APPLICATION NO.	FILING DATE	FIRST NAMED INVENTOR	ATTORNEY DOCKET NO.	CONFIRMATION NO.
10/620,084	07/14/2003	Shinji Arai	03410/LH	7394
1933	7590	04/23/2004	EXAMINER	
FRISHAUF, HOLTZ, GOODMAN & CHICK, PC 767 THIRD AVENUE 25TH FLOOR NEW YORK, NY 10017-2023			THOMAS, ERIC W	
		ART UNIT	PAPER NUMBER	2831
DATE MAILED: 04/23/2004

Office Action Summary	Application No.	Applicant(s)
	10/620,084	ARAI ET AL. <i>[Signature]</i>
Examiner	Art Unit	
Eric W Thomas	2831

FIG.1

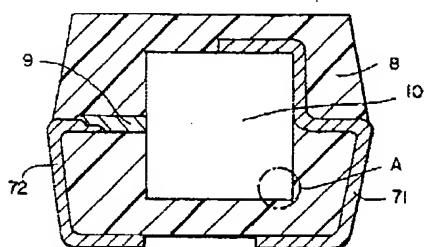
Arai et al. disclose in fig. 1 & 2, a solid electrolytic capacitor comprising a lead wire (9); an anode member (1) formed by a sintered member of a valve-action metal powder and embedding therein the lead wire; a dielectric layer (2) formed on a surface of the anode member, a first electrolyte layer (3) formed on the dielectric layer; a cathode member (5) formed on the first electrolyte layer; a silver paste layer (6) formed on the cathode member, external terminals (71,73) respectively connected to the lead wire and the silver paste layer; and a resin package molded (8) so as to expose the external terminals, said solid electrolytic capacitor further comprising non-conductive particles (silica) between the dielectric layer and the cathode member, and a second electrolyte layer (4) formed between the dielectric layer and the cathode member, wherein the second electrolyte layer is formed so as to contain the non-conductive particles.

Arai et al. disclose the claimed invention except for the first electrolyte layer includes particles constituting the cathode member.

Sakara et al. teach the use of graphite particles formed within an electrolytic layer (see fig. 1B – element 5).

It would have been obvious to a person of ordinary skill in the art at the time the invention was made to modify the capacitor of Arai et al. by using a graphite powder material in the first electrolyte layer, since such a modification would increase the surface area of the electrolyte layer and improve contact resistance.
